UNITED STATES PATENT AND TRADEMARK OFFICE

APPLICATION NO.	FILING DATE	FIRST NAMED INVENTOR	ATTORNEY DOCKET NO.	CONFIRMATION NO.
10/576,610	04/21/2006	Toshio Yamauchi	0969-0187PUS1	2059
2292 7590 12/22/2008 BIRCH STEWART KOLASCH & BIRCH PO BOX 747 FALLS CHURCH, VA 22040-0747				
EXAMINER MORGAN, EMILY M				
ART UNIT 3677		PAPER NUMBER		
NOTIFICATION DATE 12/22/2008		DELIVERY MODE ELECTRONIC

Office Action Summary

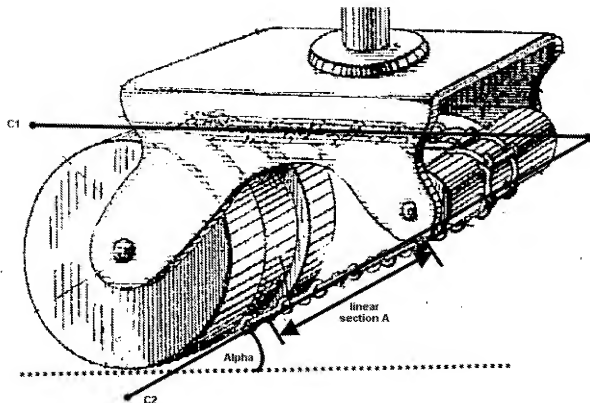
Regarding claim 1, Rison discloses a caster (figure, shown below) comprising: first 19 and second 21 wheels disposed forward and back and an endless wrap-around member 22 wrapped around the first 19 and second 21 wheels, the first and second wheels having common tangents C1 and C2, the common tangent C2 having an angle (alpha) with respect to a ground surface, wherein the wraparound member 22 is a continuous endless belt formed by connecting a plurality of pieces (links, line 56) via a plurality of connecting members, the wraparound member having a linear portion A formed along at least the common tangent C2 of the wheels (all shown below). Rison does not disclose the specified structure of the wraparound member.
